INNER WEST COUNCIL

Re: Sydney Gateway Motorway Project

Thank you for providing Council and the Community with the opportunity to provide feedback on the Sydney Gateway Environmental Impact Statement. In response Council provides the following comments, noting that the project will continue to be subject to on-going discussions between Council officers and representatives of the Sydney Gateway Team (TfNSW).

Figure 2 – Sydney Gateway Proposed Active Transport Links (arrows show Link 1 and Link 2)

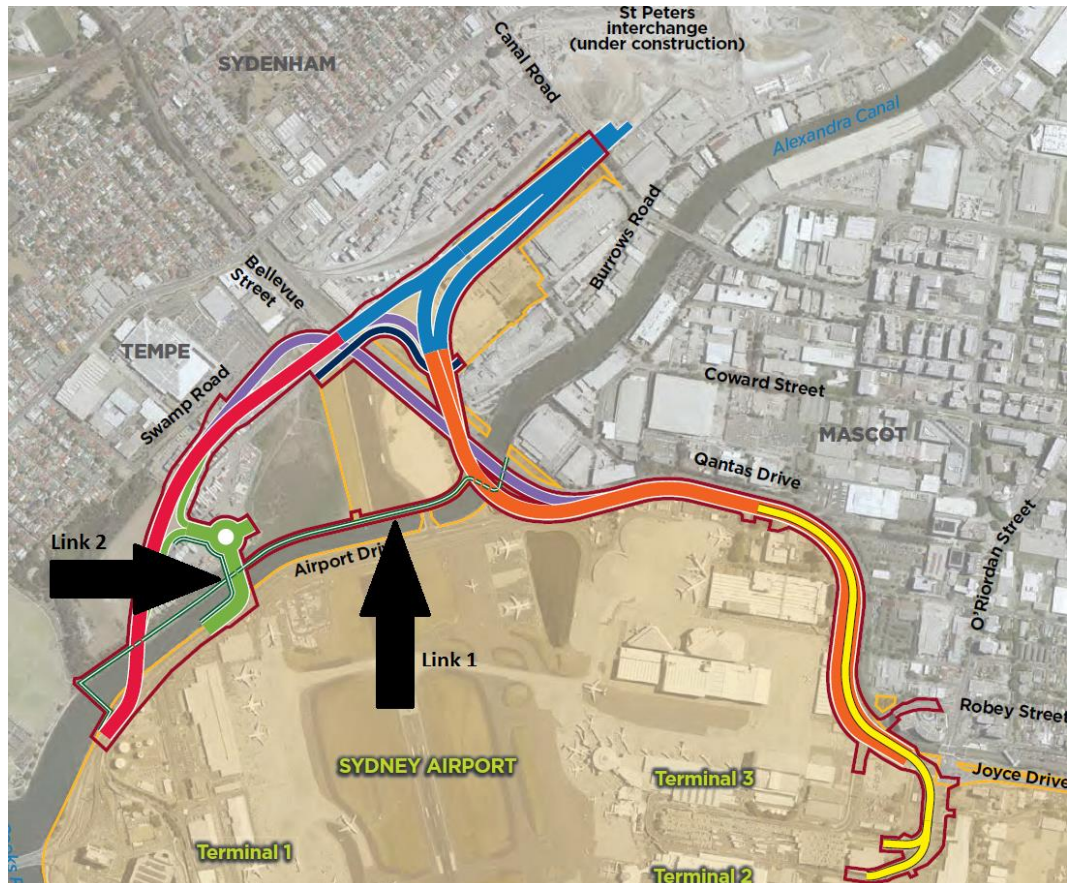
- a) **Active transport links (proposed)** - The two active transport links proposed in the EIS (and shown in Figure 2) are supported, however concern is expressed that these two links do not provide sufficient connectivity to the surrounding active transport network. It is considered that the project provides a window of opportunity to significantly enhance active transport throughout the area, including connectivity to the surrounding active transport network, and that this should be capitalised on in the project proposed active transport plan.

Additionally, concern is expressed that the shared path along the Alexandra Canal may be subject to hazardous flooding in the future. Consequently, it is requested that details of the proposed mitigation measures should be provided.

It is requested that the Project's Active Transport Plan include the following connectivity:

Figure 3 – Temporary Alexandra Canal Active Transport Link (during construction)

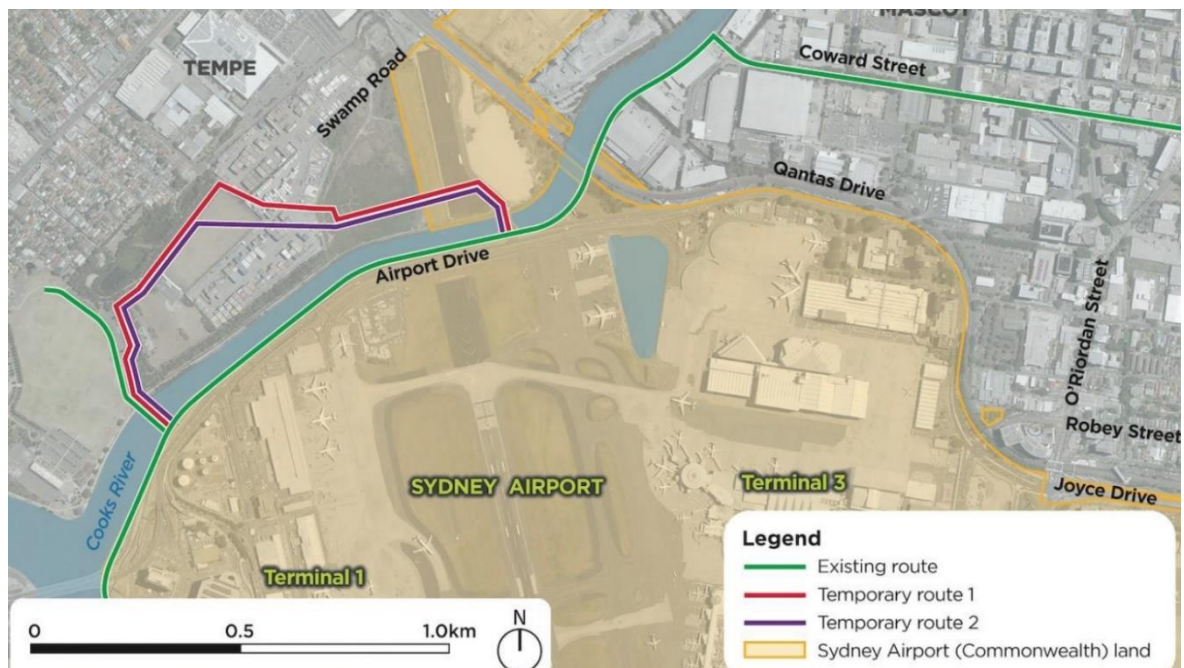
b) Temporary Active Transport Links (during construction and shown in Figure 3) - the points are raised for consideration, based on the temporary active transport measures proposed during the project’s construction:

- Any conditions of consent associated with active transport links during construction must specify the provision of routes which are safe, direct, with no additional time or distance burdens and with maximum gradients of 5 per cent. The wording of conditions on major infrastructure now under construction in the Inner West LGA, have resulted in people walking significantly longer distances with delays at signalised intersections and with cyclists being diverted through narrow, steep, winding, indirect paths mixing with heavy vehicles.

- In order to adequately assess potential conflict along the temporary routes significantly greater detail should be provided. Of particular concern is the operational viability of the cycleway during the lifespan of the construction works and interaction of the cycleway and worksite traffic.

The proposed Active Transport Plan will be prepared in consultation with all adjacent Councils, the local Community and local bicycle user groups to ensure all construction and operation issues above are addressed. These issues will particularly include enhanced connectivity, additional links and improved staging of construction.

Figure 5 – Contamination assessment areas

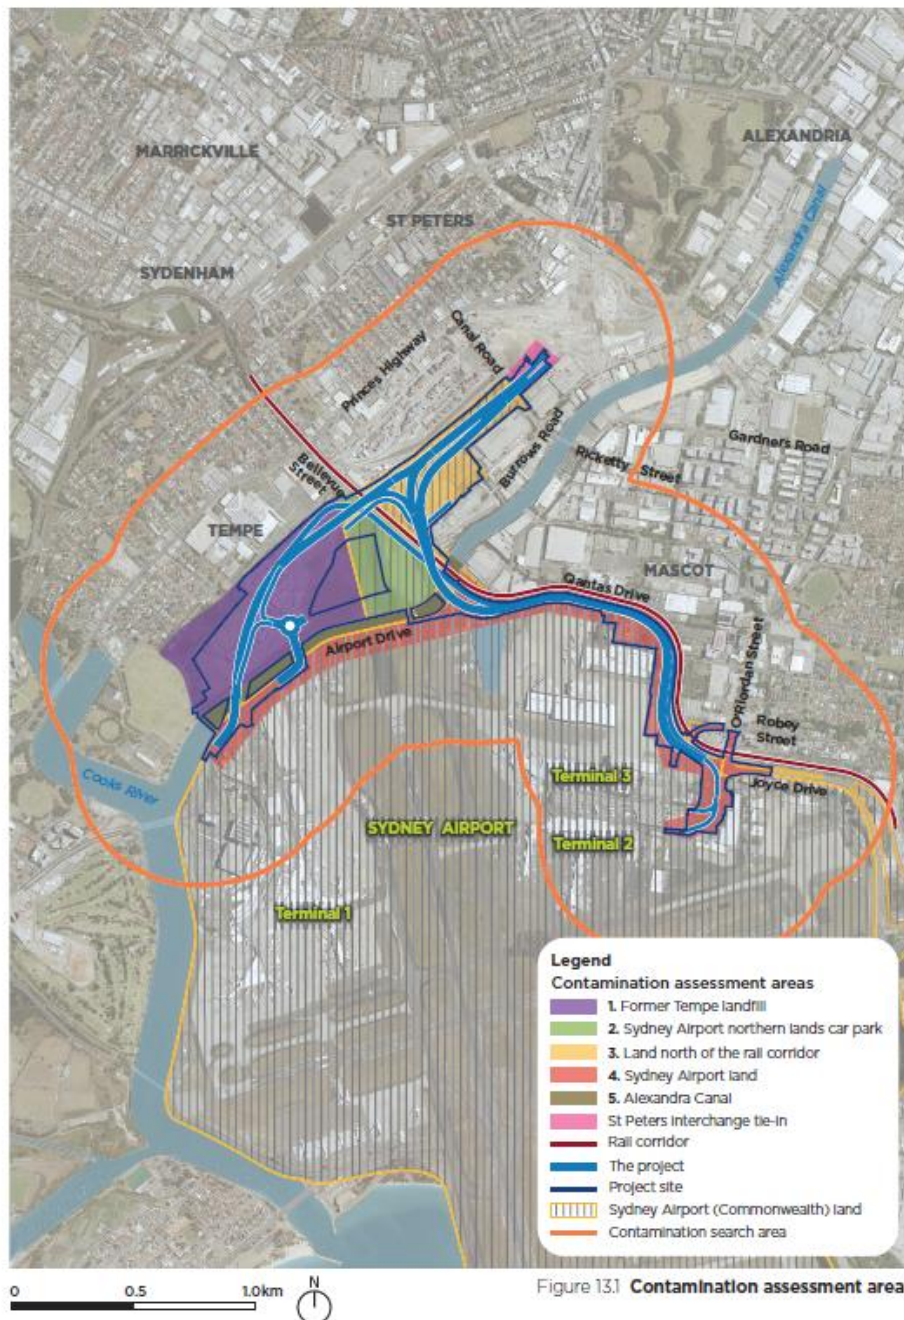
Figure 13.5 (CSM) should have included landfill gas migration across the north-western boundary
